Our Ref: 20044I01A-200714

**RE: 11-17 COLUMBIA LN, HOMEBUSH
TRAFFIC RESPONSE TO COUNCIL'S COMMENTS**

As requested, MLA Transport Planning (MLA) has reviewed the traffic and parking related comments raised by Strathfield Council in relation to the above development application. MLA provides our responses these matters herein.

Figure 1: Traffic Circulation Routes

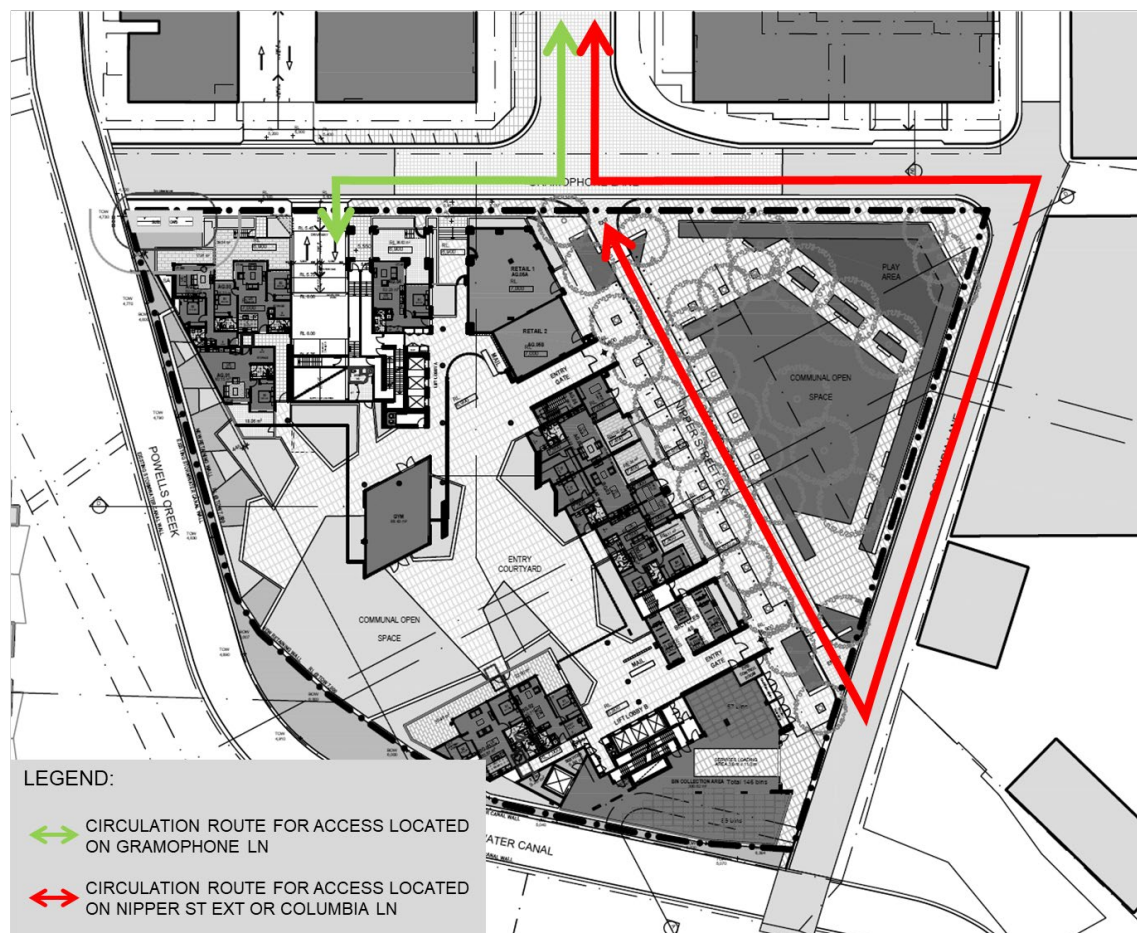
The development 'turns its back on' an active transportation corridor and does not present a pedestrian friendly environment along the corridor that links the development, surrounding developments and the triangular communal open space to the Powell's Creek linear open space.

The location of the basement car park access, in combination with the existing basement access to the residential tower development at 6 – 18 Colombia Lane, concentrates car movements along the link to the Powell's Creek linear open space.

The subject site has frontages to Gramophone Lane, Nipper Street extension as well as Columbia Lane. As such, access driveway to serve the proposed development could potentially be located on any one of these frontage streets. However, from a traffic circulation perspective Gramophone Lane provides the most optimal location for reasons explained below.

The majority of the traffic accessing the subject proposed development and the one at 6-16 Parramatta Road would do so using the Nipper Street intersection with Parramatta Road. If the access to the proposed development was located on Gramophone Lane as proposed, traffic would turn right into Gramophone Lane from Nipper Street then turn directly into the development without having to circulating around the site. However, if the access was located on Nipper Street extension or Columbia Lane, traffic would need to circulate and travel around the block across most of the site. The circulation patterns for the different access location options are shown in Figure 1.

As can be seen from Figure 1, access located on either Nipper Street extension or Columbia Lane would result in vehicles un-necessarily circulating across most the site.

In addition, due to this circuitous route arising from the access driveway being located on Nipper Street extension or Columbia Lane, pedestrians within the site would potentially be exposed to more circulating traffic and conflicts than otherwise would be necessary if the access driveway was located on Gramophone Lane.

Figure 2: Existing 2020 Traffic Conditions

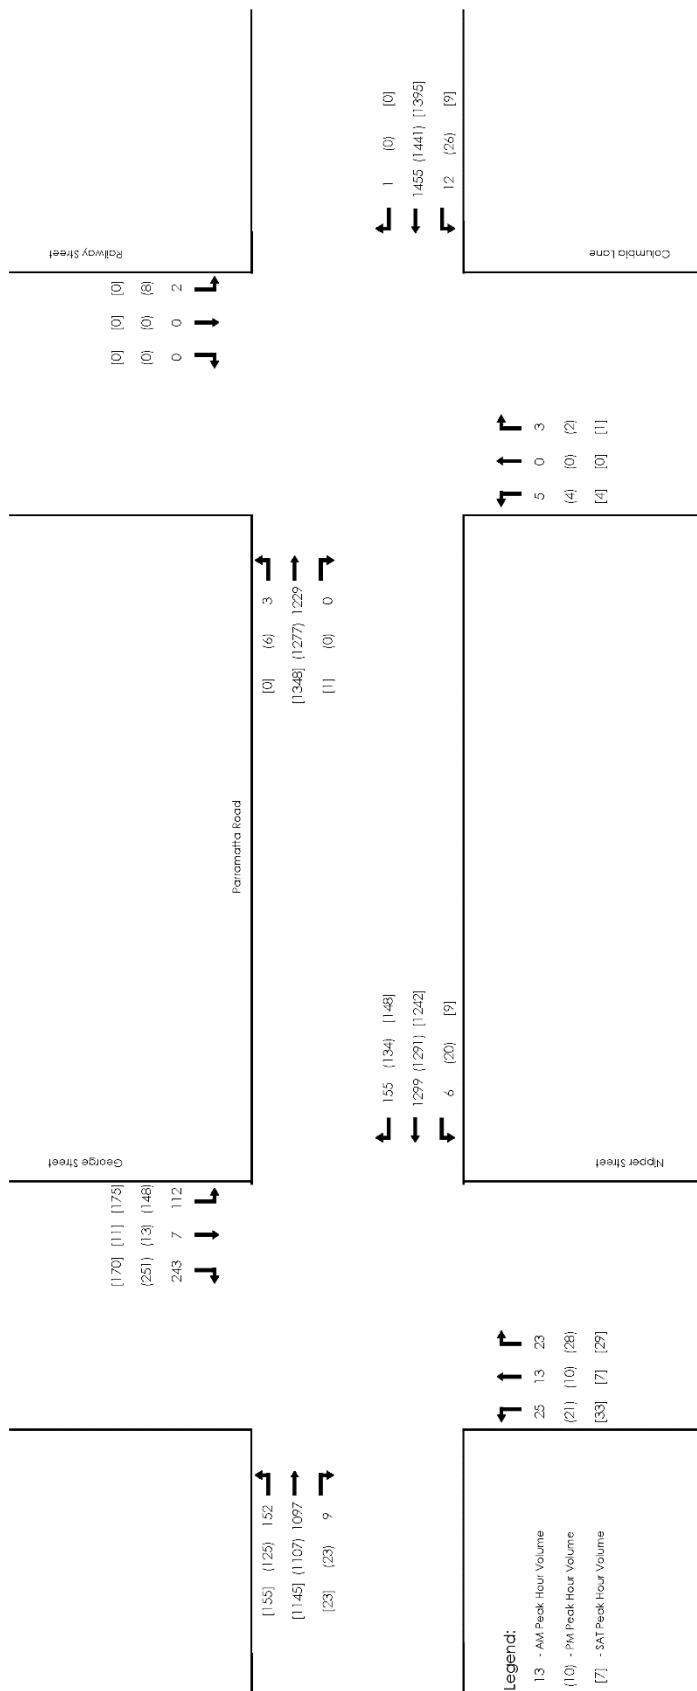
The application does not provide an up-to-date analysis of intersection performance. Council requires an updated SIDRA analysis be submitted which:

- i. Is based on the latest traffic survey results;*
- ii. Incorporates all approved and committed developments to confirm and re-consider the scale and access arrangement as this may have changed since 2015;*
- iii. Ensures all intersection LoS is D or above;*
- iv. Includes the Parramatta Road and Columbia Lane intersection;*
- v. Uses SIDRA network modelling as required or otherwise provide justification;*
- vi. Provide details of the SIDRA analysis, in particular queuing analysis, SCATS data, and signal setting.*

MLA has conducted SIDRA analysis based on the latest traffic surveys conducted on Thursday 28 May 2020 and Saturday 30 May 2020 for the following peak periods:

- Scenario 1 2020 existing traffic conditions (based on May 2020 traffic surveys) – see Figure 2, and
- Scenario 2 2020 traffic conditions with traffic from the proposed development on the subject site and known development – see Figure 3.

The traffic modelling results for the existing traffic conditions indicate that the Nipper Street intersection with Parramatta Road operates with satisfactory traffic performance with level of service (LoS) D or better in all assessed peak periods.

However, the Columbia Lane intersection with Parramatta Road is currently operating with LoS F. The poor performance at this intersection is due to the right turn movement on the side streets (Columbia Lane and Railway Street). Traffic surveys indicate these movements carry little to no traffic. If these movements are banned from the network,

DRAWING TITLE:
VEHICLE SWEEPED PATH -
AS2890.1 5.2M B99 TURNING
AROUND ON DRIVEWAY

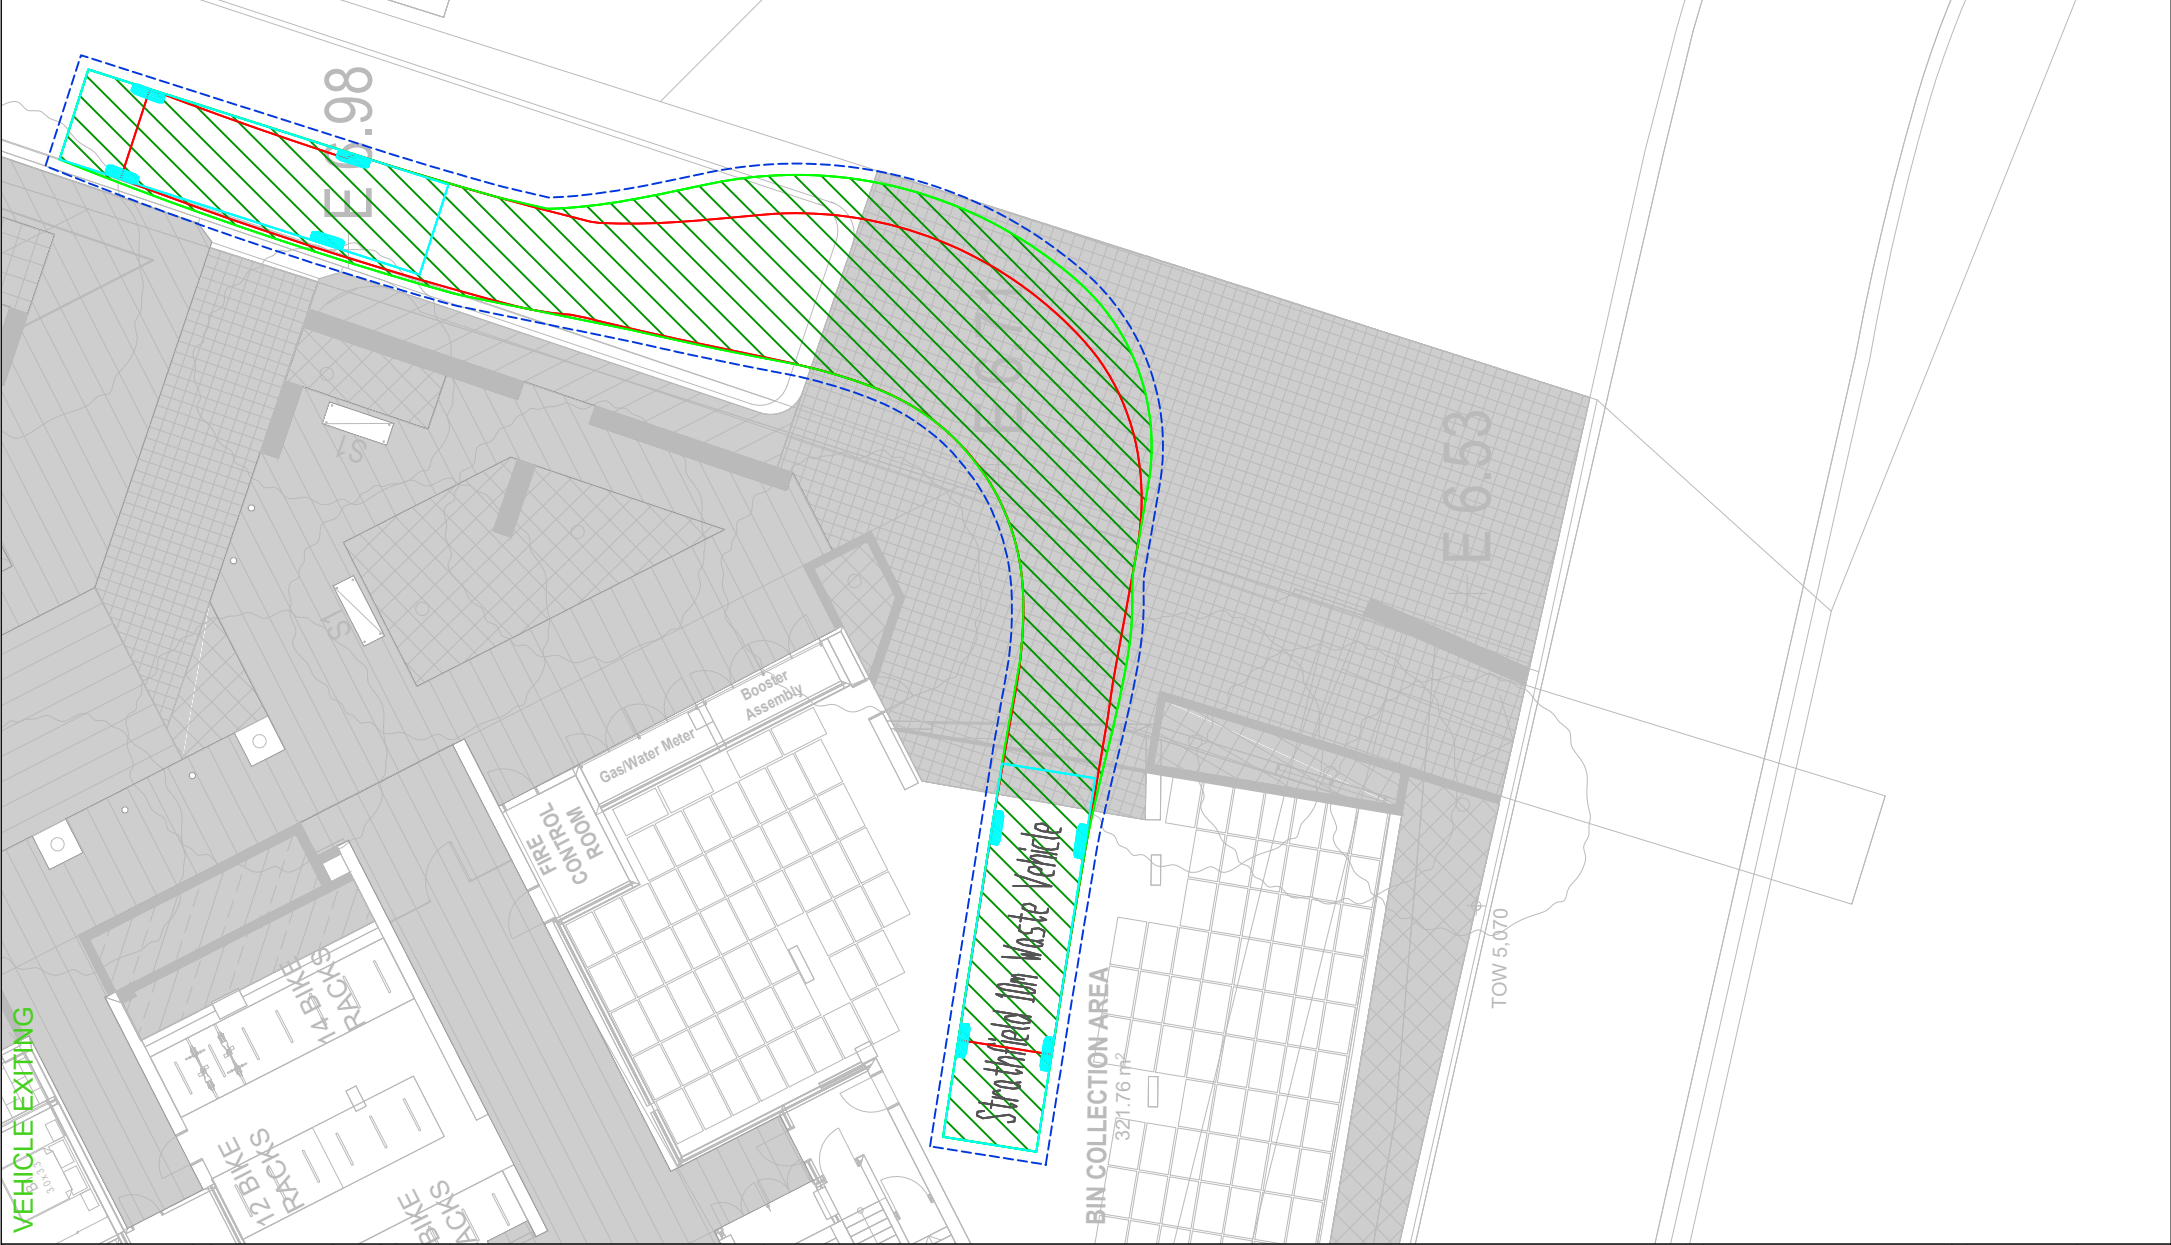
The basement layout does not satisfy the minimum queuing requirements and accessible parking requirements. Council considers a turnaround porch area should be included prior to the control point.

Council requested for a turnaround area prior to the control plan. It is noted that the current design permits a visitor vehicle to turn around to leave the site in a forward direction in the event that the tenant is not available. Swept path diagram provided in Attachment Two demonstrates that an Australian Standard B99 vehicle can turn around on the driveway prior to the control point using five movements. This is considered to be satisfactory.

DATE:	14 JULY 2020	SCALE:	1:200@A3
DRAWING NO.:	20044CAD001B-002	REV:	B
DRAWING TITLE:			
VEHICLE SWEEP PATH - STRATHFIELD COUNCIL 10M WASTE TRUCK ACCESSING LOADING BAY			
PROJECT:			
11-17 COLUMBIA LN, HOMEBUSH

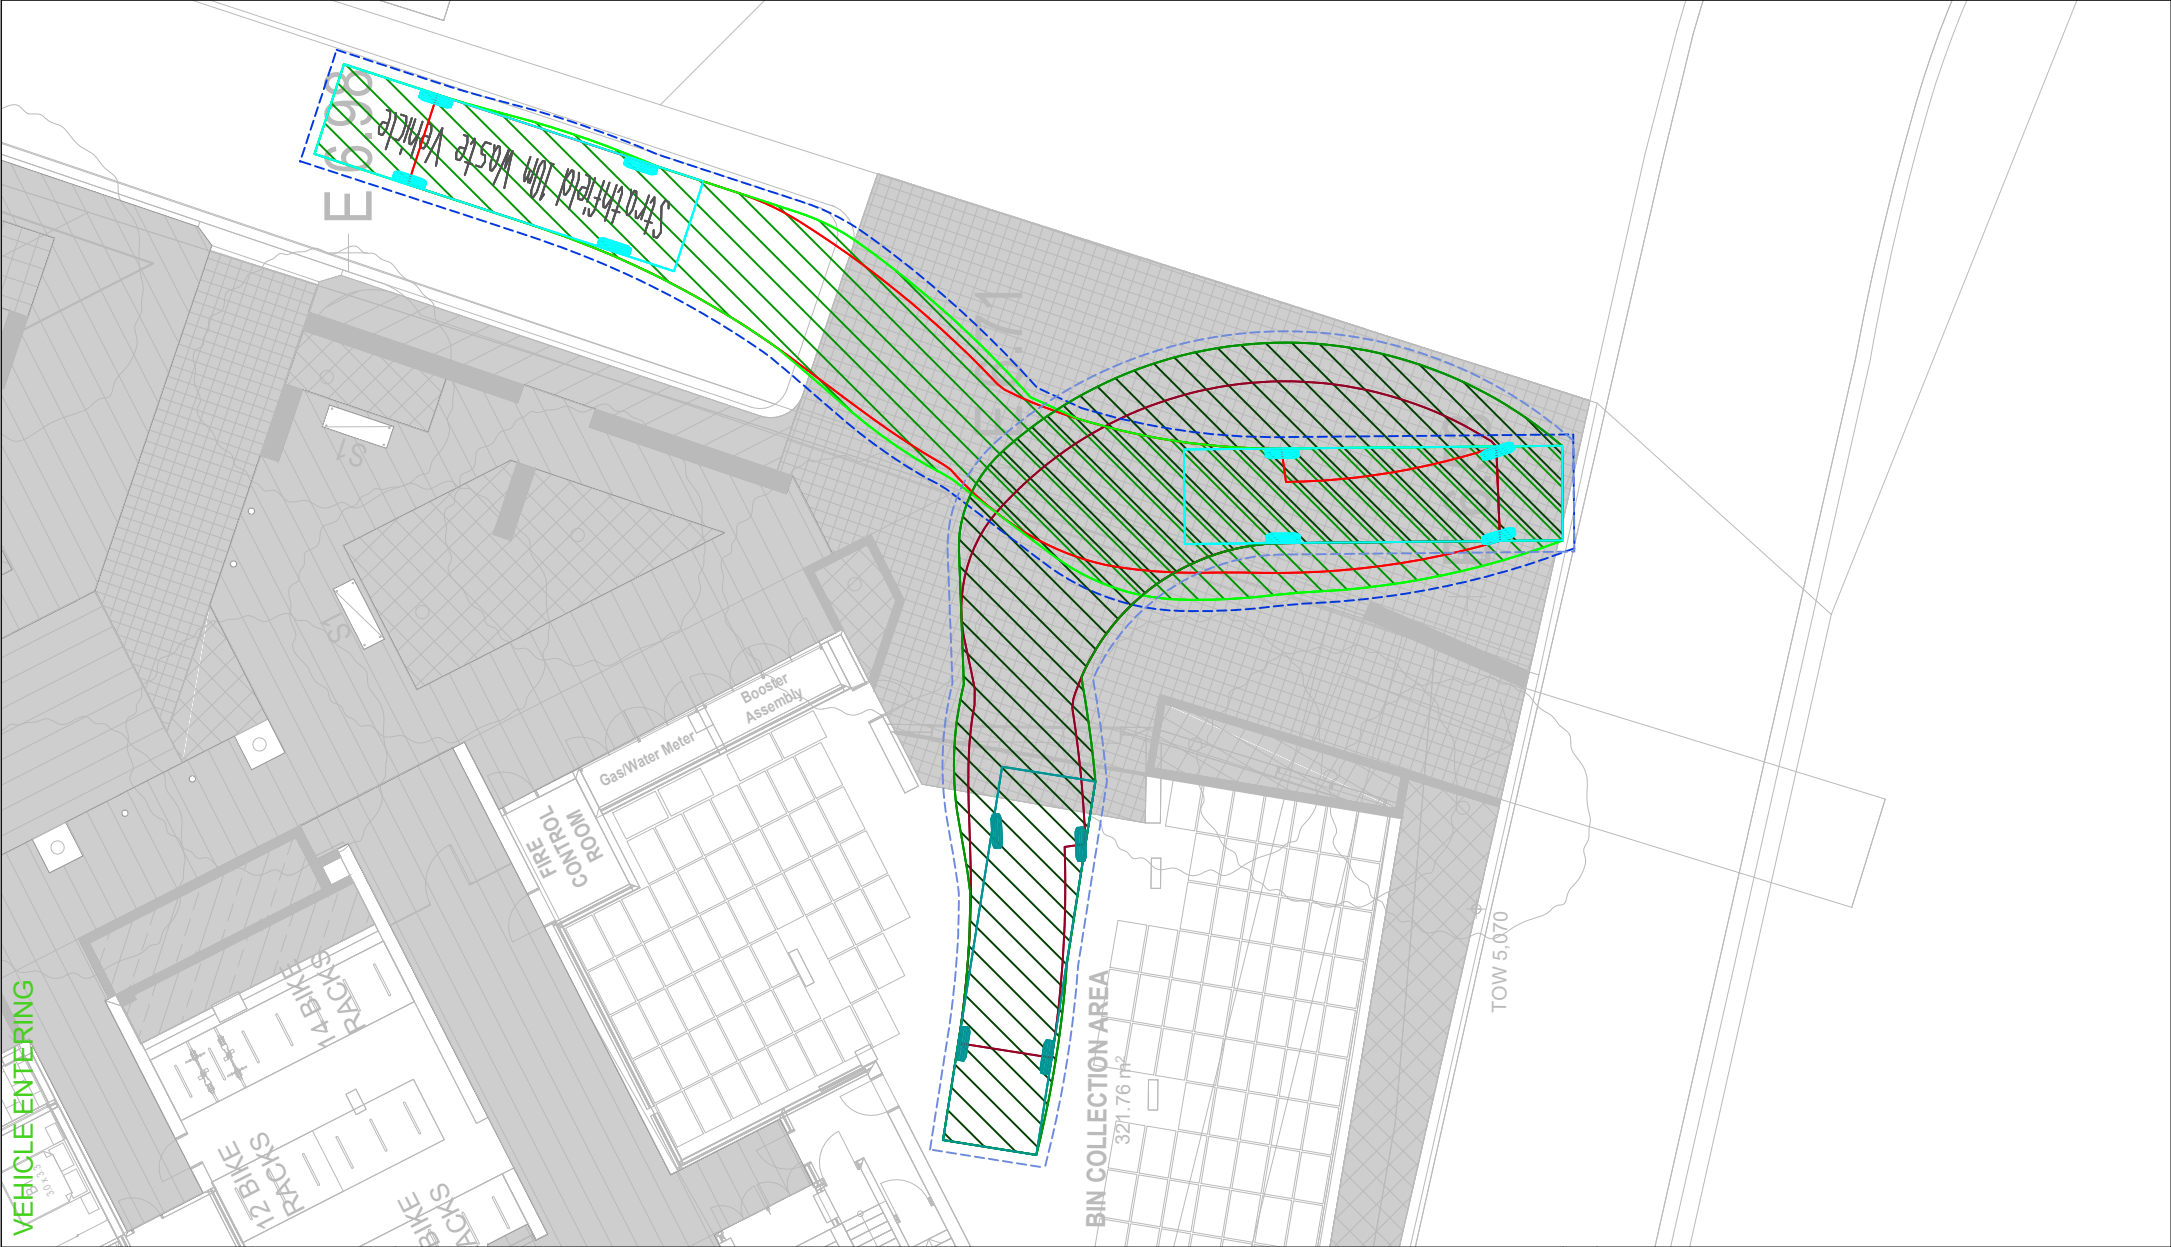
The waste collection point is inadequate and requires redesign to demonstrate compliance with the following:

- i. Along-side the driveway into the site;*
- ii. 10m rear loader accessible – turning circle 18m kerb to kerb;*
- iii. Length of standing area 10m;*
- iv. 3.6m height clearance;*
- v. Gradient of ramps maximum 1:5.*

The current scheme proposes a loading bay to be shared by all tenants of the proposed development. This is located at the ground level off Columbia Lane. The dimensions of the proposed loading bay comply with the dimensional requirements set out in the DCP i.e. 10m long by 3.6m wide with headroom of 3.6m.

MLA has conducted swept path analysis of a 10m waste collection vehicle accessing the proposed loading bay. The swept path analysis indicates the waste collection

vehicle is able to access the loading bay without any issues. The relevant swept path diagrams are contained in Attachment Two.

From the above, the proposed loading bays complies with the design requirements set out in the DCP and have satisfactory access to and from Columbia Lane.
